UNITED STATES PATENT AND TRADEMARK OFFICE

APPLICATION NO.	FILING DATE	FIRST NAMED INVENTOR	ATTORNEY DOCKET NO.	CONFIRMATION NO.
10/599,363	07/23/2008	Hedi Slimane	28944/50047	7383

Office Action Summary	Application No. 10/599,363	Applicant(s) SLIMANE, HEDI	
	Examiner DEVIN BARNETT	Art Unit 3637

DETAILED ACTION

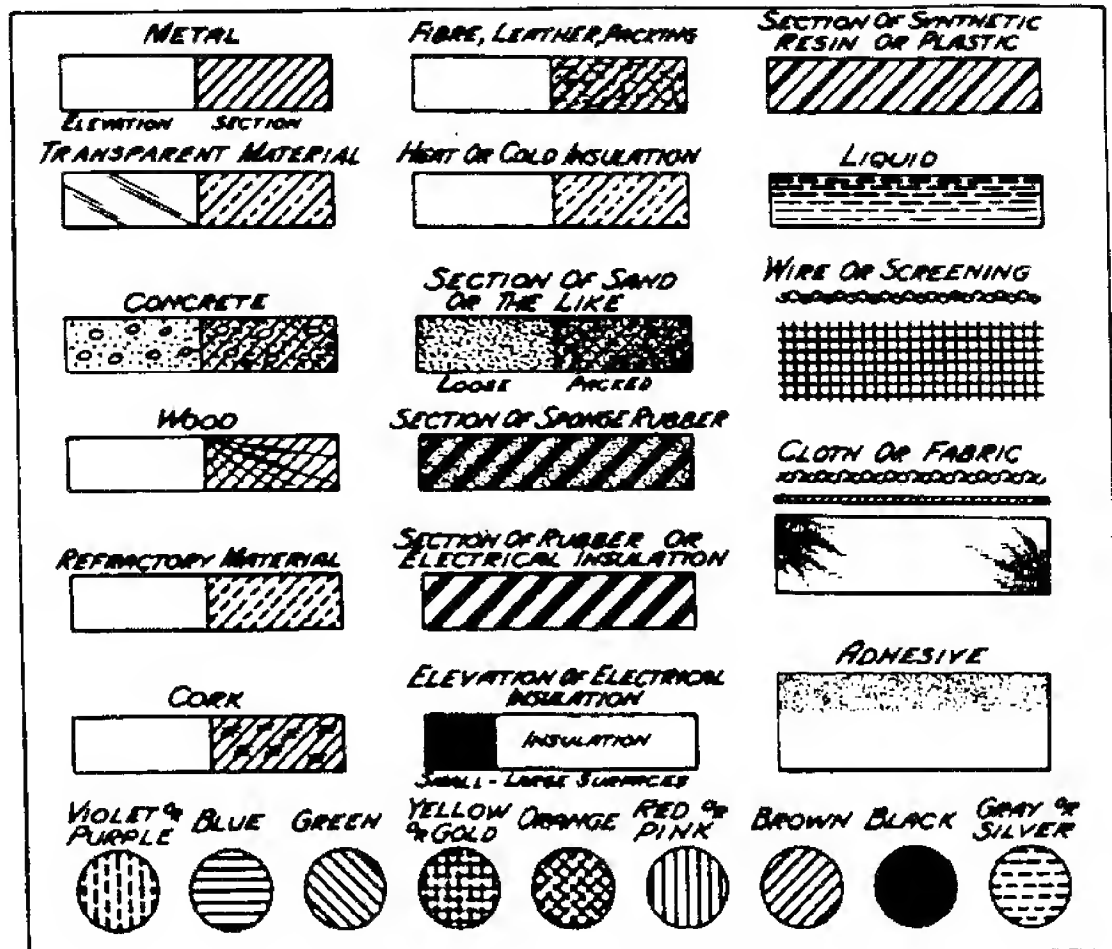
The drawings are objected to under 37 CFR 1.83(a). The drawings must show every feature of the invention specified in the claims. Therefore, the transparent plate resided in claim 6 must be shown with the correct hatch marks (a chart is provided below 37 CFR 1.84(n)) or the feature(s) canceled from the claim(s). No new matter should be entered.

Corrected drawing sheets in compliance with 37 CFR 1.121(d) are required in reply to the Office action to avoid abandonment of the application. Any amended replacement drawing sheet should include all of the figures appearing on the immediate prior version of the sheet, even if only one figure is being amended. The figure or figure number of an amended drawing should not be labeled as “amended.” If a drawing figure is to be canceled, the appropriate figure must be removed from the replacement sheet, and where necessary, the remaining figures must be renumbered and appropriate changes made to the brief description of the several views of the drawings for consistency. Additional replacement sheets may be necessary to show the renumbering of the remaining figures. Each drawing sheet submitted after the filing date of an application must be labeled in the top margin as either “Replacement Sheet” or “New Sheet” pursuant to 37 CFR 1.121(d). If the changes are not accepted by the examiner, the applicant will be notified and informed of any required corrective action in the next Office action. The objection to the drawings will not be held in abeyance.

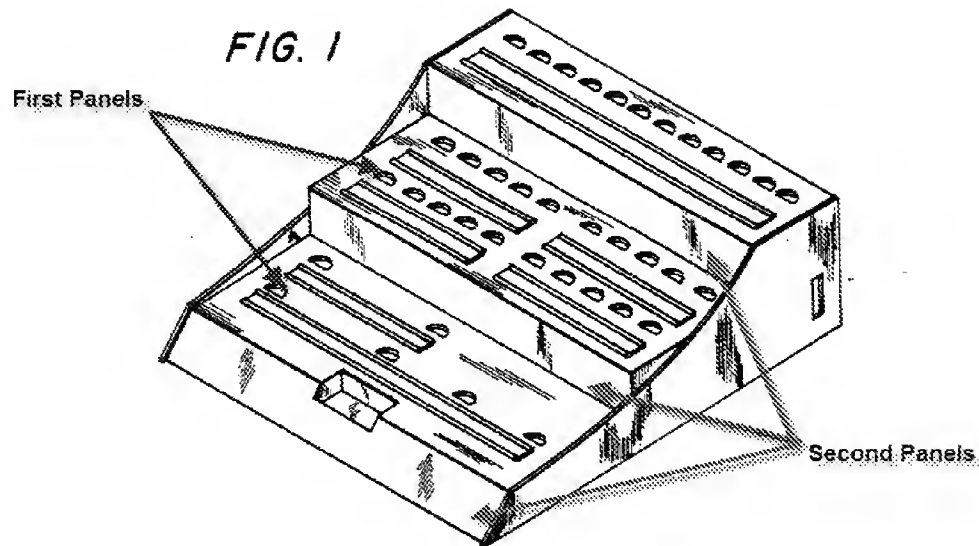
Regarding claim 1, Richman discloses a vertical display stand for articles such as cosmetic products, comprising: a vertical board that has a rear face and a front face, said front face formed at least partially by a plurality of first panels (annotated Fig 1 below) and a plurality of second panels (annotated Fig 1 below); the first and second panels being produced as a single piece together with the board; wherein said first and second panels are superposed vertically in alternance (as shown below); wherein the first panels are adapted to accommodate said articles.

Richman does not explicitly teach a display stand wherein the first panels are non transparent and the second panels are inclined relative to the first panels; wherein the first and the second panels define reliefs substantially in the form of crests, and at least one of the second panels arranged opposite one of the first panels has a reflective surface and is facing slantwise forward and downward such that a person facing the board can observe only a top portion of said articles, either directly, or indirectly by reflection in the second panel placed opposite said first panel.

It would have been obvious to one having ordinary skill in the art at the time the invention was made to fabricate the first panels from a non transparent material such as metal, since it has been held to be within the general skill of a worker in the art to select a known material on the basis of its suitability for the intended use as a matter of obvious design choice.

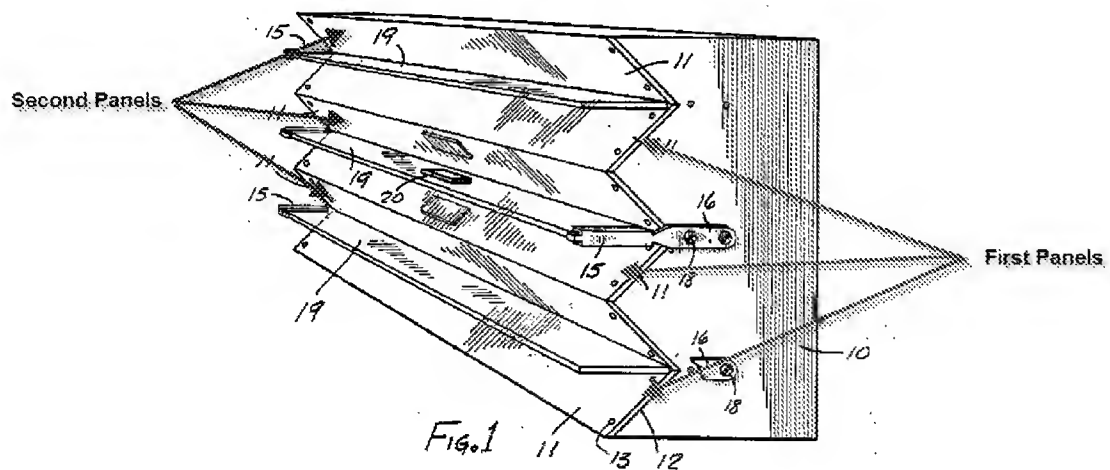
Einbinder discloses a display stand wherein the second panels (annotated Fig 1 below) are inclined relative to the first panels (annotated Fig 1 below); wherein the first and the second panels are superposed vertically in alternance thereby defining a relief substantially in the form of a crest (as shown in Fig 1), and at least one of the second panels arranged opposite one of the first panels has a reflective surface and is facing slantwise forward and downward.

It would have been obvious to one having ordinary skill in the art at the time the invention was made to modify the first and the second panels disclosed in Richman to be inclined as taught by Einbinder, because such a modification would have involved a mere change in the shape of a component. A change in size and shape is generally recognized as being within the level of ordinary skill in the art. Further, it would be obvious to
